Mullica Township Government Building

Addendum 1: Narrative

DEMOLITION PLANS

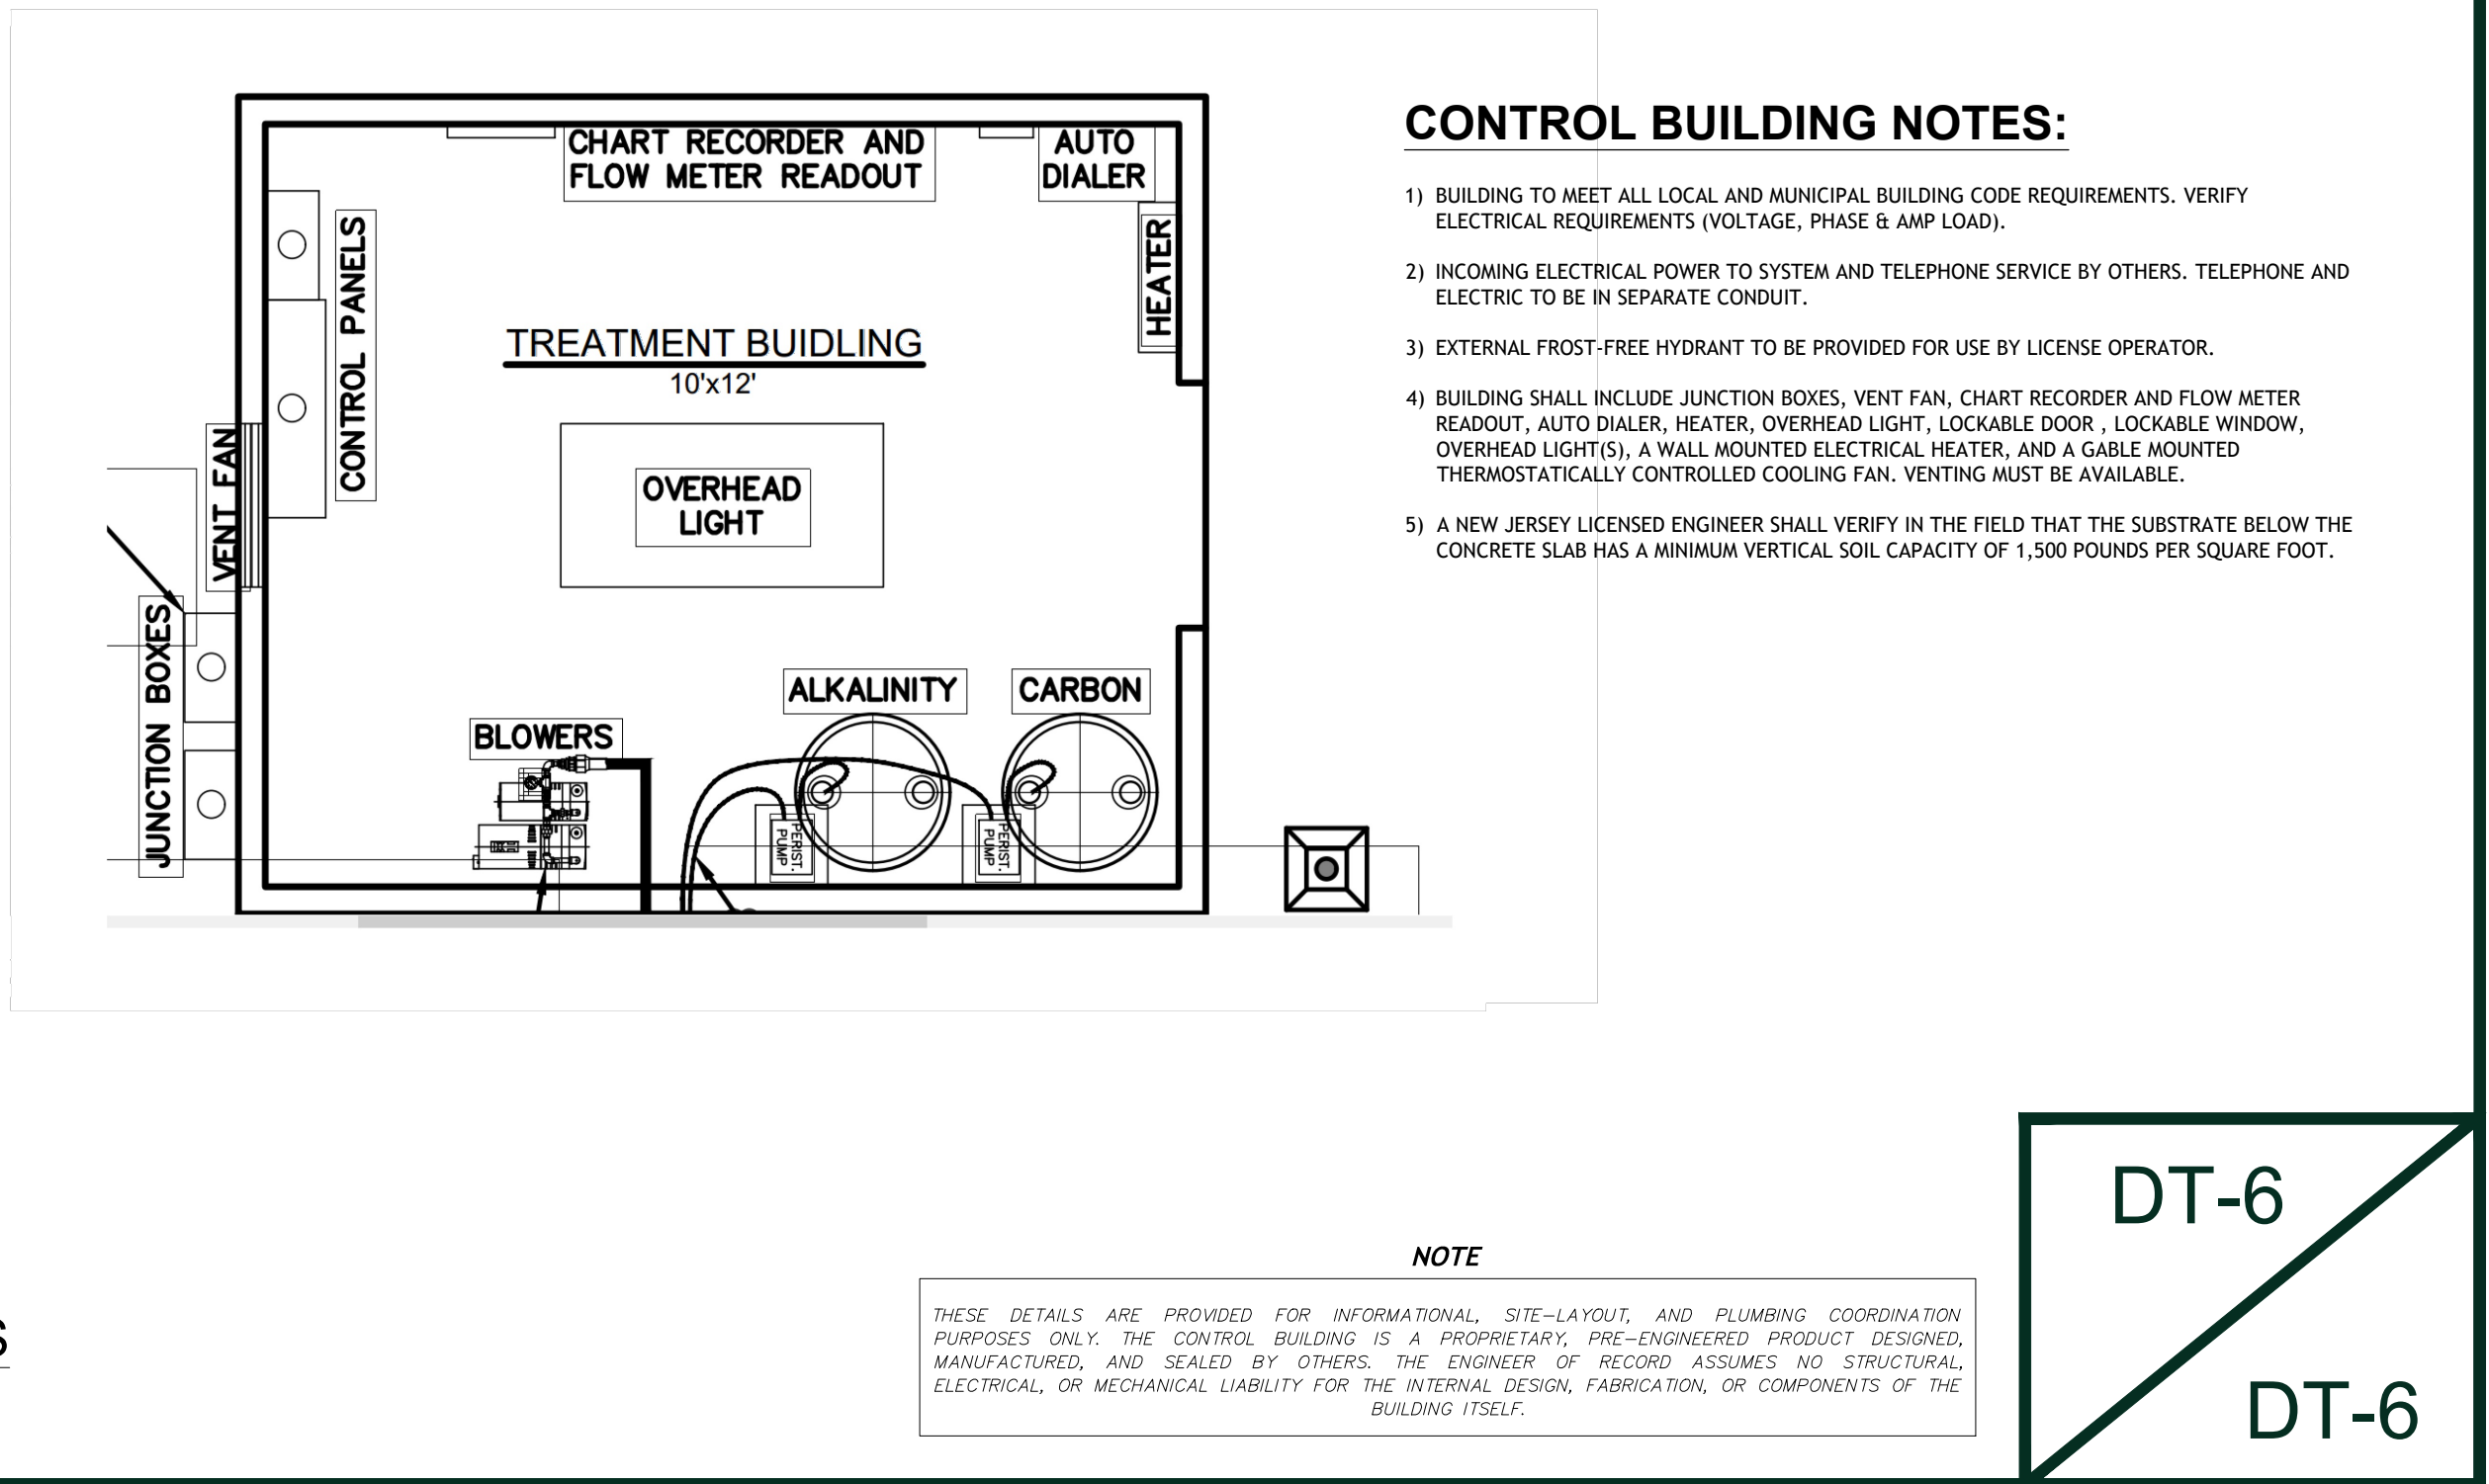
D1.00: Roof Demolition plan has been updated

041	A1.12	Drawing A1.12 indicates "new asphalt shingle roof finish" on the existing town hall building, however, drawing D1.00 states "hip roof to remain, protect during all phases...". Please clarify if roof is existing to remain for is intended to be removed and replaced during construction.	07.20.26	07.24.26	THE EXISTING ROOF FINISH IS TO BE REMOVED AT THIS LOCATION, THE SHEATHING AND STRUCTURE BELOW ARE TO REMAIN AND BE PROTECTED. A NEW UNDERLAYMENT AND ROOF FINISH ARE TO BE INSTALLED. SHEET D1.00 HAS BEEN REVISED IN ADDENDUM 1 TO CLARIFY.

2 EAST ELEVATION
3/16" = 1'-0"

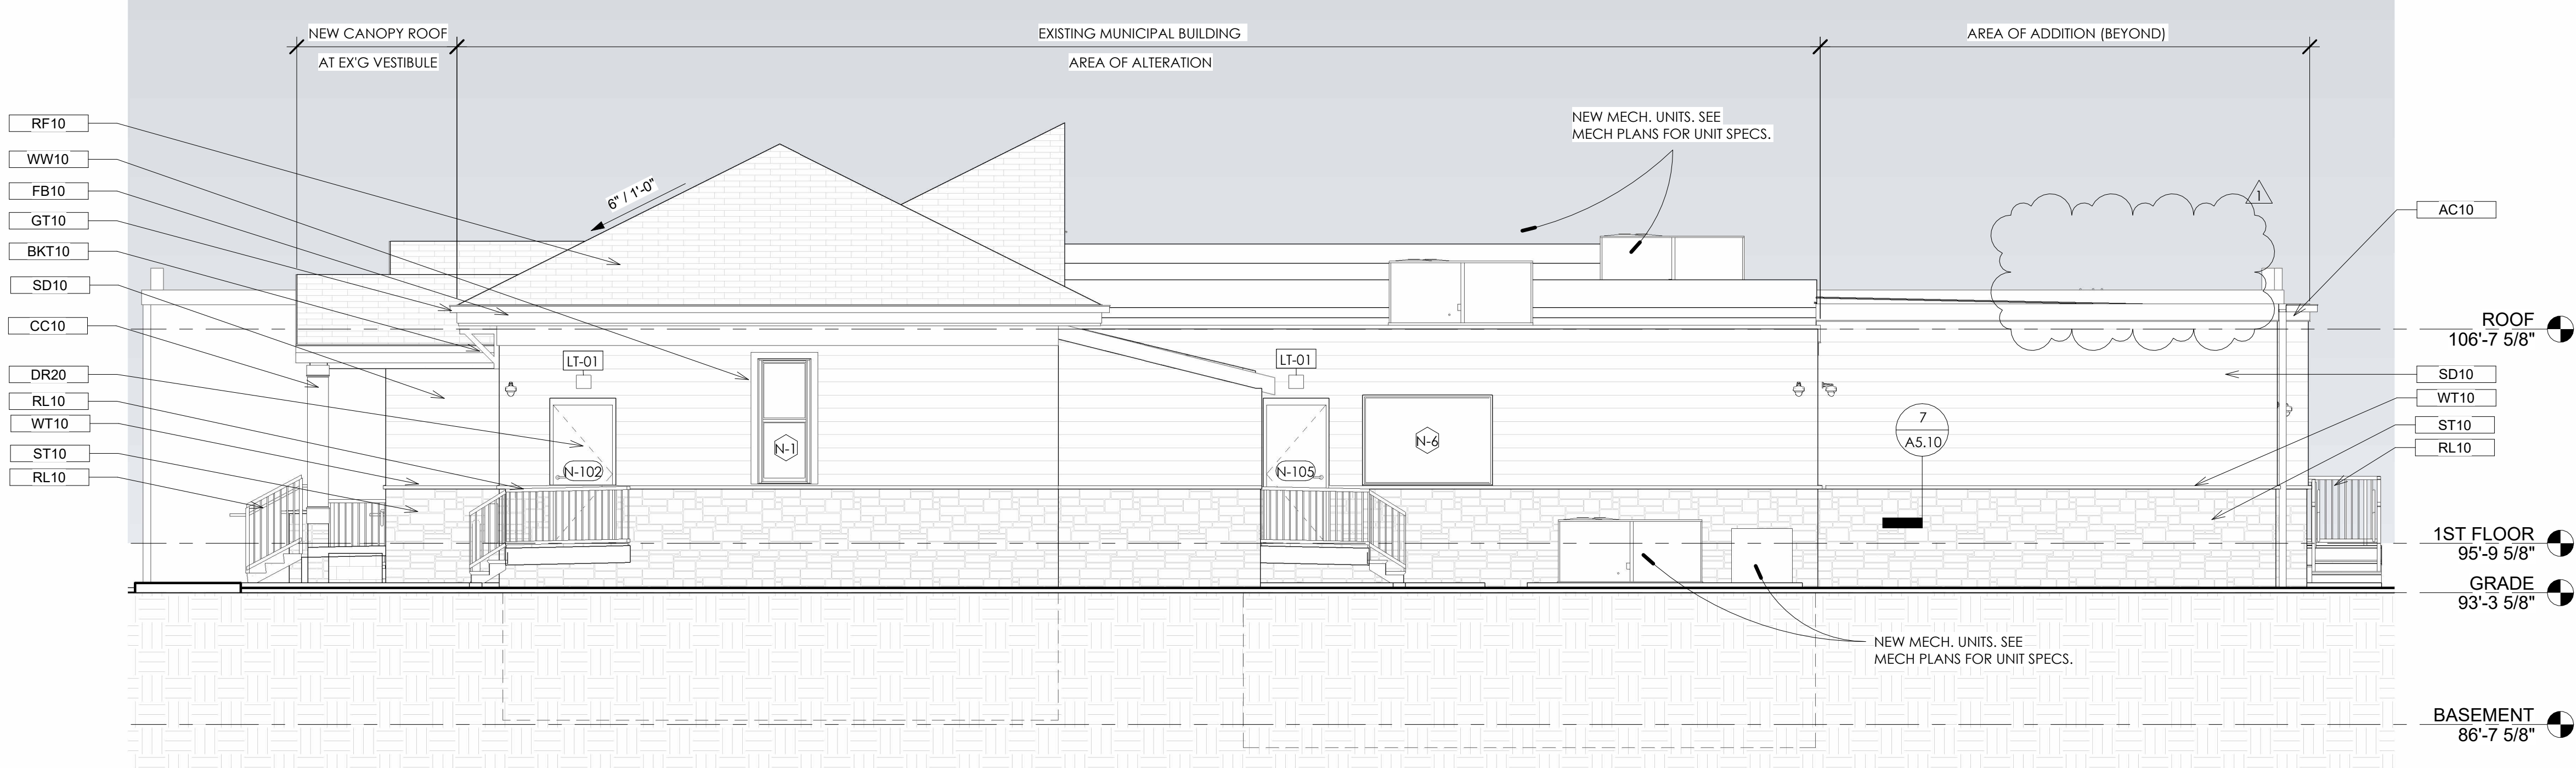
A2.02: An unused detail callout from the East Elevation has been removed

1 ENLARGED PLAN - LOBBY RESTROOM
1/2" = 1'-0"

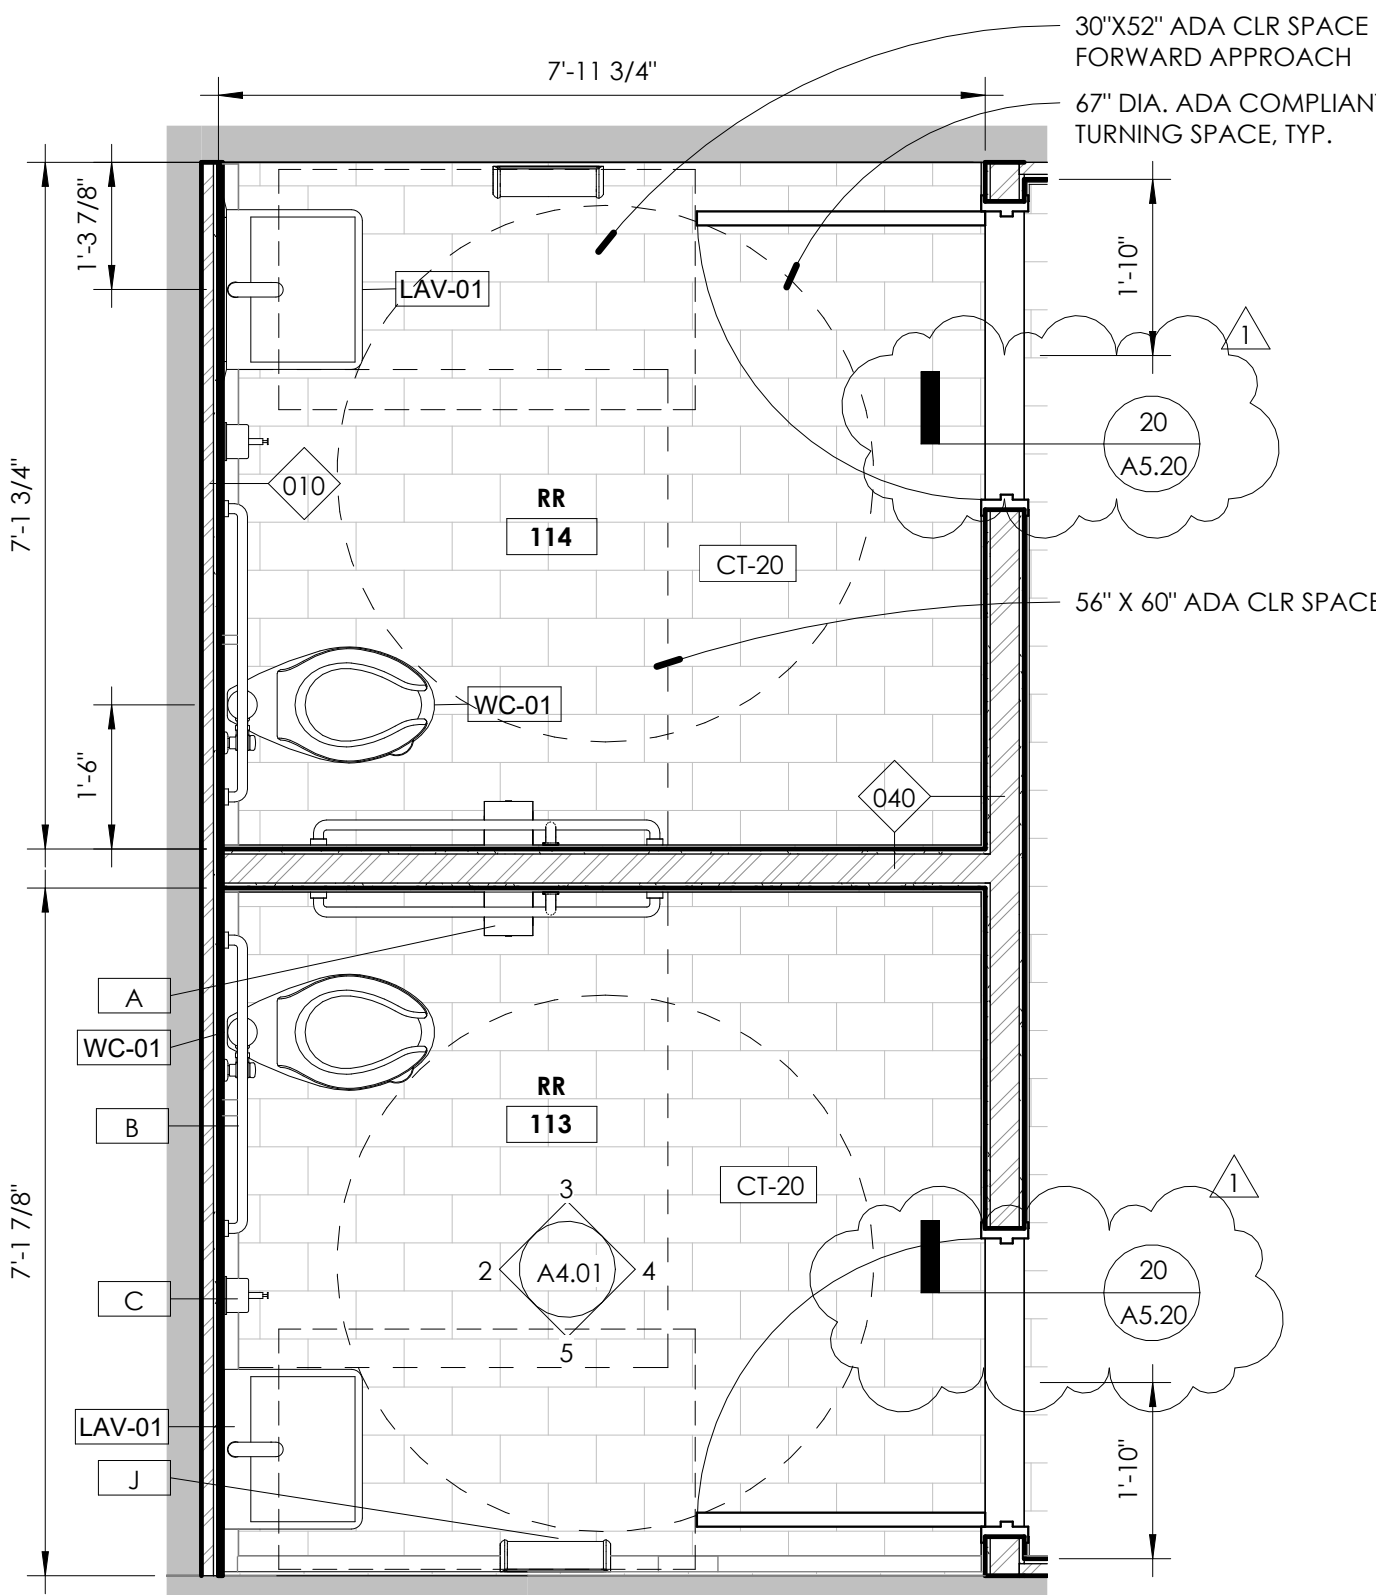
A4.01: The threshold detail callouts have been added to Drawing 1. Drawing 3 finishes have also been updated.

2 NEW/EX'G FOOTING DETAIL
1" = 1'-0"

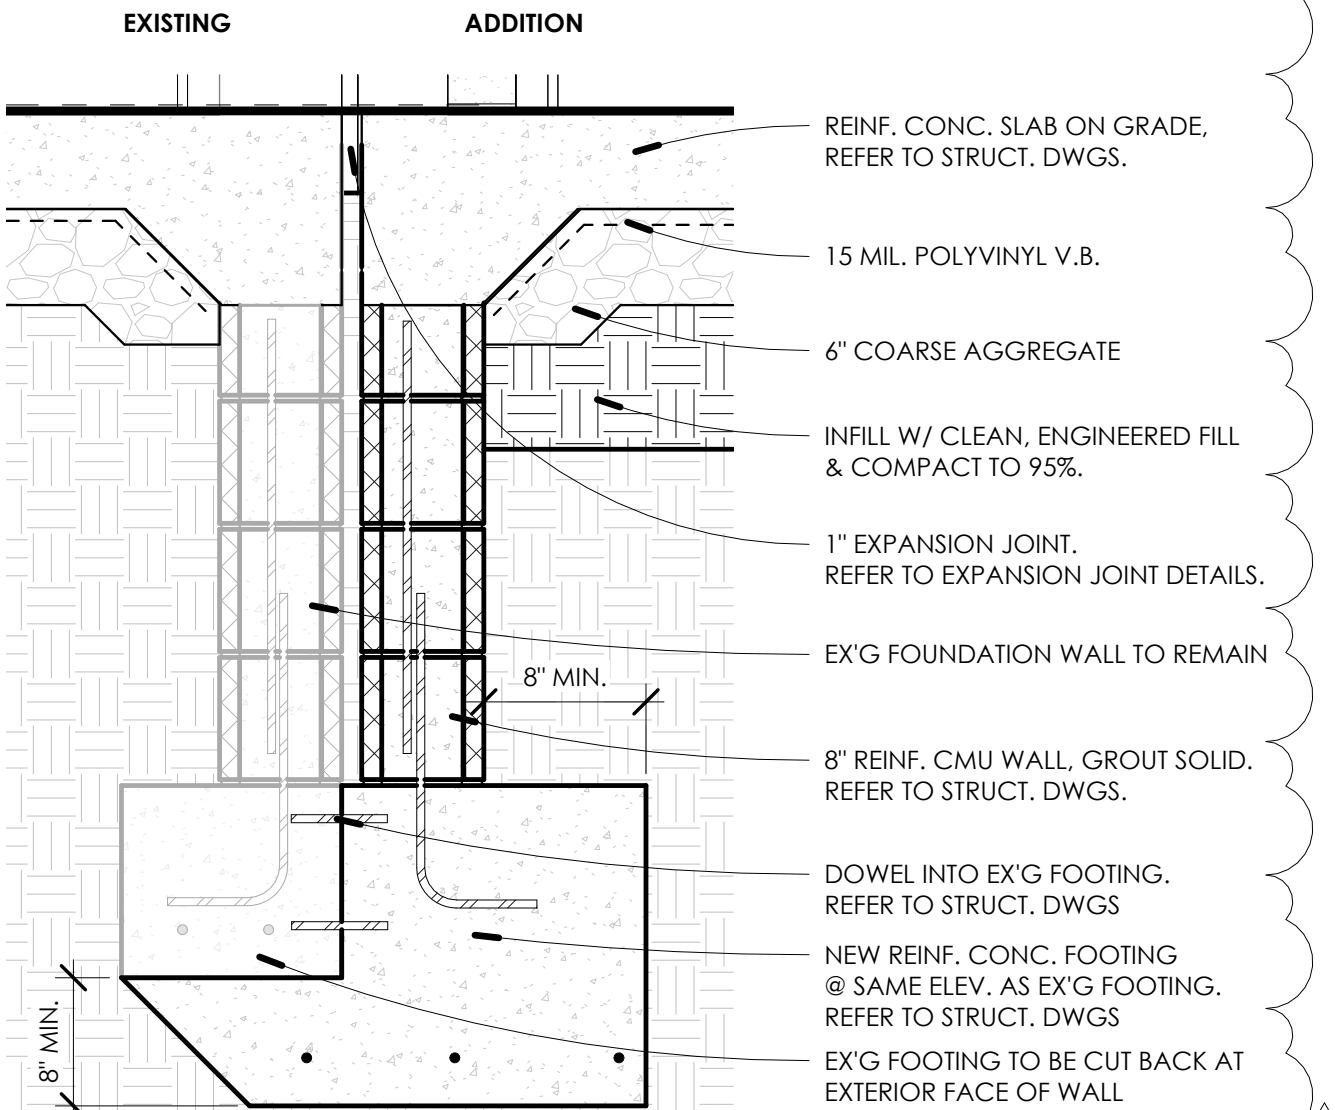
A5.10: Revised New/Ex'g Footing Detail.

017	-	Please confirm whether a dedicated Contractor field office and/or construction trailer is required for this project. If required, please identify the minimum requirements, permitted location, utility responsibilities, and any Owner-provided accommodations.	07.20.26		THIS QUESTION IS TO BE ADDRESSED IN ADDENDUM 2.
018	A5.10 S3	Please clarify the details where the new foundation abuts the existing foundation. Detail F/S3 shows underpinning and extending the existing footing without dowels. Details 2&3/A5.1 show cutting back the existing footing and doweling the new footing to the existing footing. 1.If we are to follow detail F/S3 please provide a drawing of the sequencing of the underpinning.	07.20.26	07.24.26	THE DETAIL IN THE STRUCTURAL DRAWINGS IS TO BE USED. SHEET A5.10 HAS BEEN REVISED IN ADDENDUM 1 TO MATCH.
